AP1000 DOCUMENT NO.	REVISION	PAGE	ASSIGNED TO	OPEN ITEMS (Y/N)
APP-GW-GLR-134	1	1 of 470	W-Sterdis

TITLE: **AP1000 DCD Impacts to Support COLA Standardization**

AP1000 Standard Combined License Technical Report

Figure 2.6.1-1 (Sheet 1 of 4)
Main ac Power System

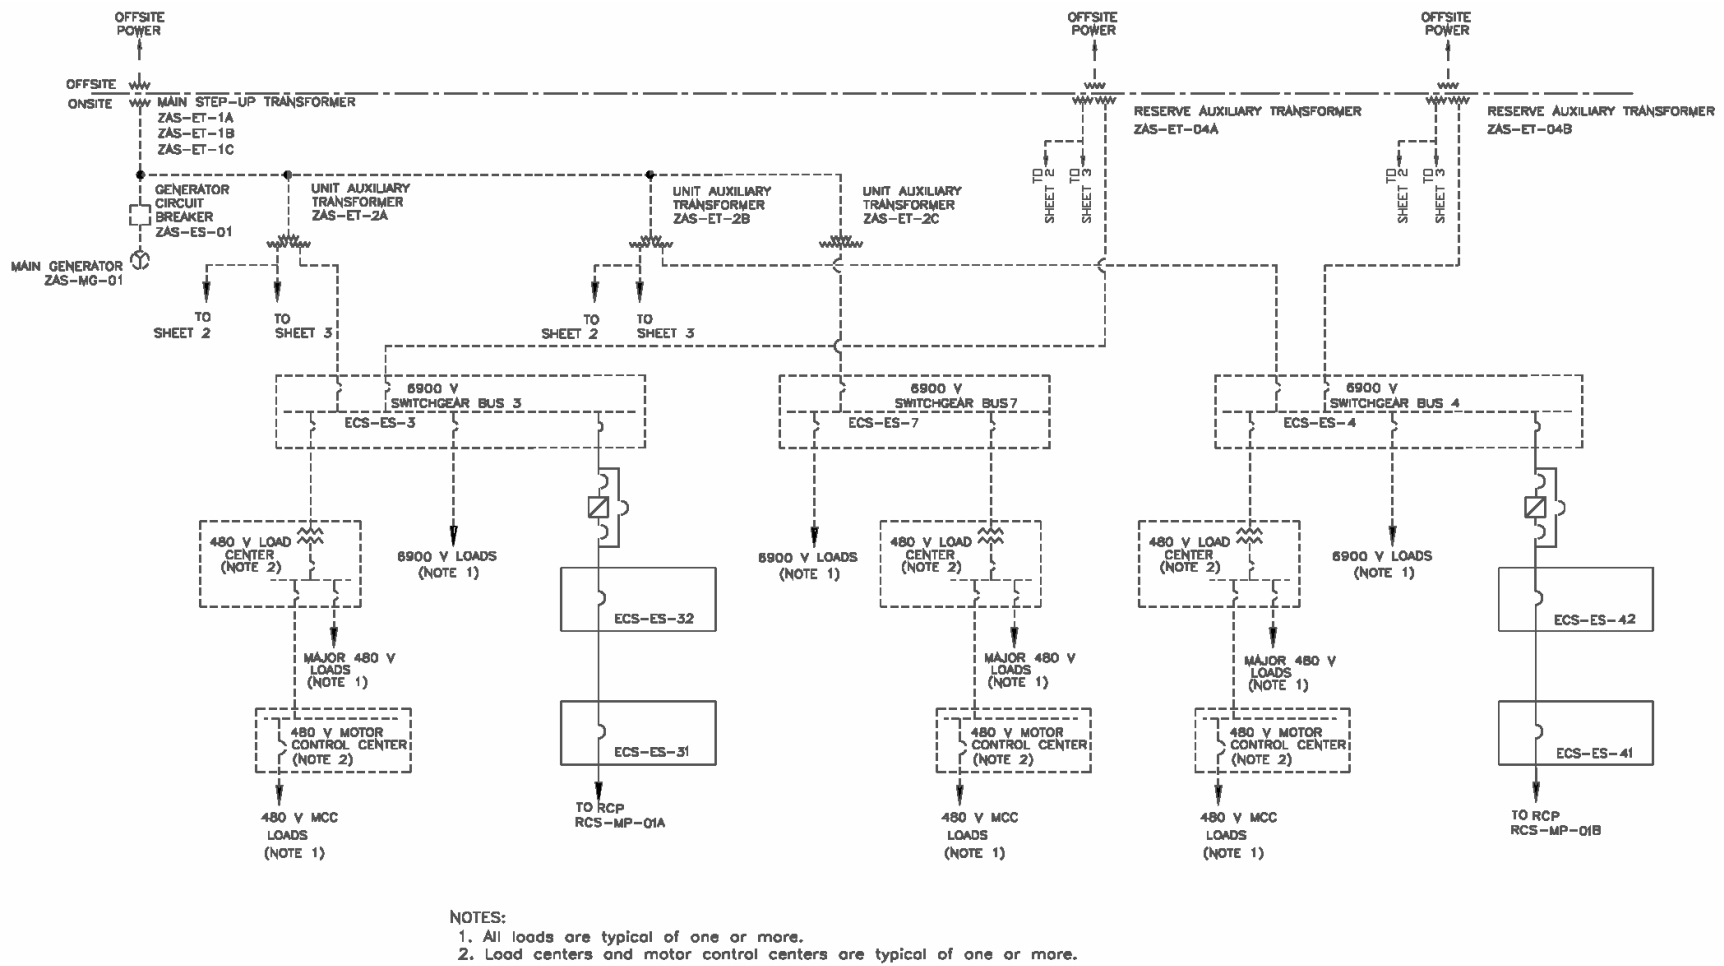
NRC078 contains corrections to Figure 2.6.1-1 of DCD Revision 16 to be consistent with APP-GW-GLN-114 (TR114) and APP-GW-GLN-079 (TR79).

Figure 3H.5-9 (Sheet 1 of 3)

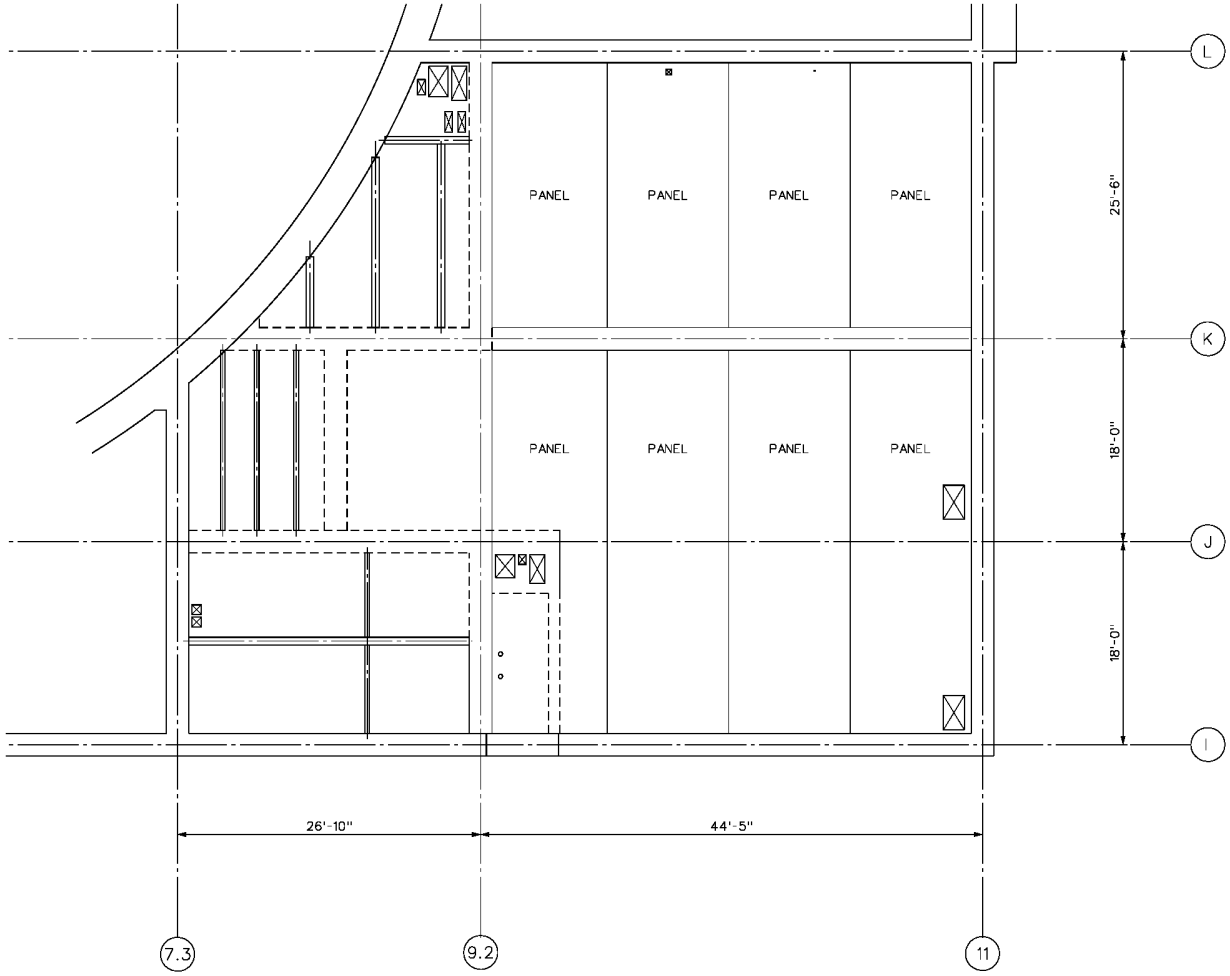
NRC 094 contains corections to Figure 3H.5-9 sheet 1 and Figure 3H.5-12 of the DCD Revision 16 to be consistent with TR 57, APP-GW-GLR-045, Rev 0.

Figure 1.2-1

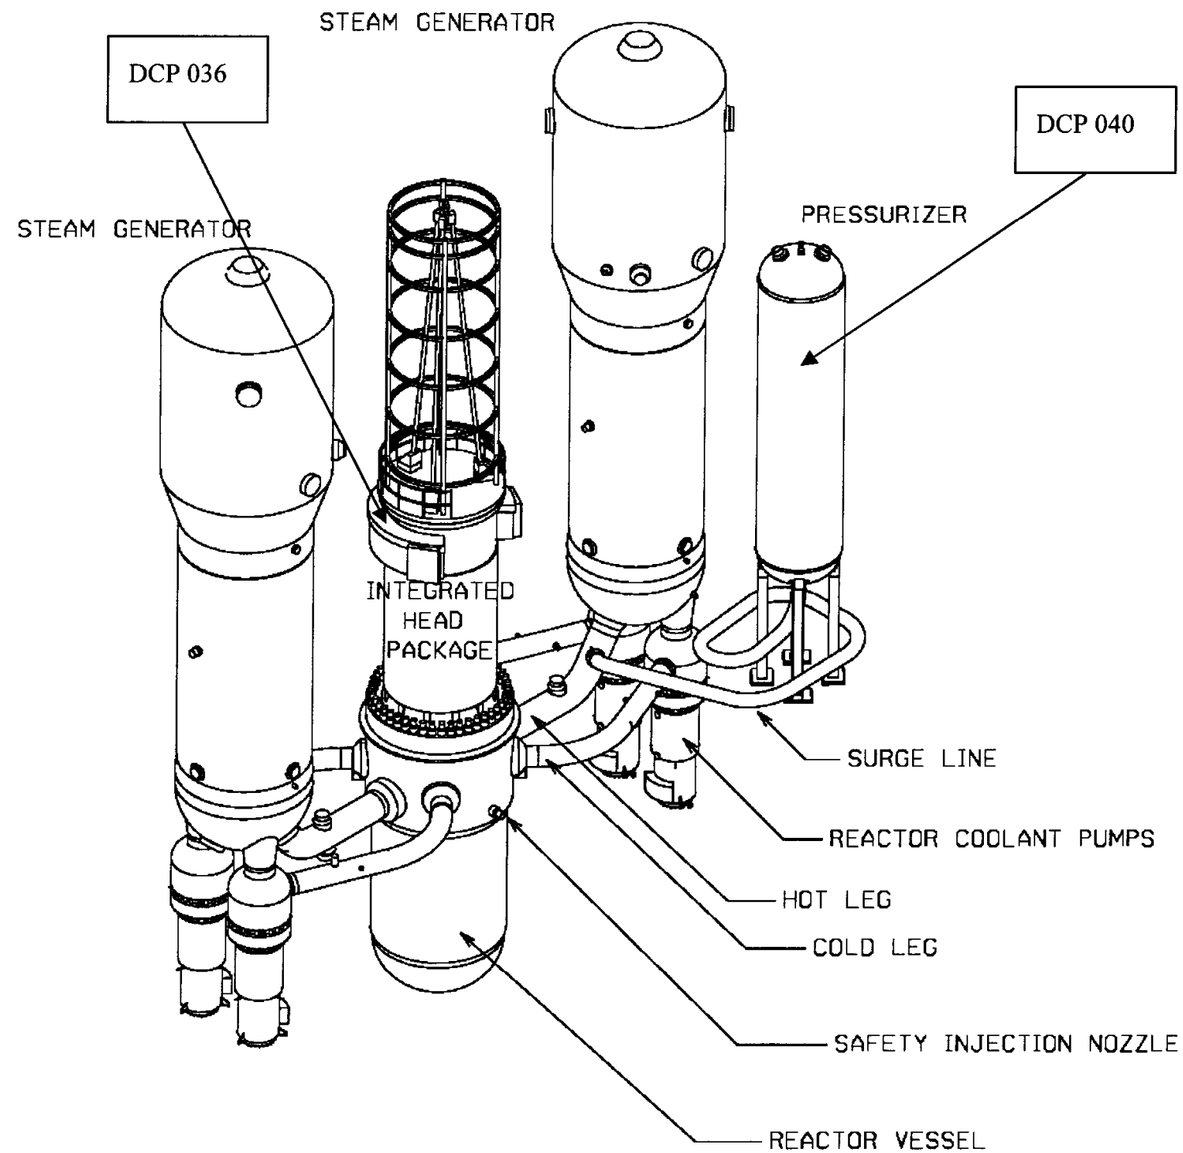
NRC106 contains corrections to Figure 1.2-1, 5.1-2 and Figure 1.2-9. The basis for the change is TR36 APP-GW-GLR-016.
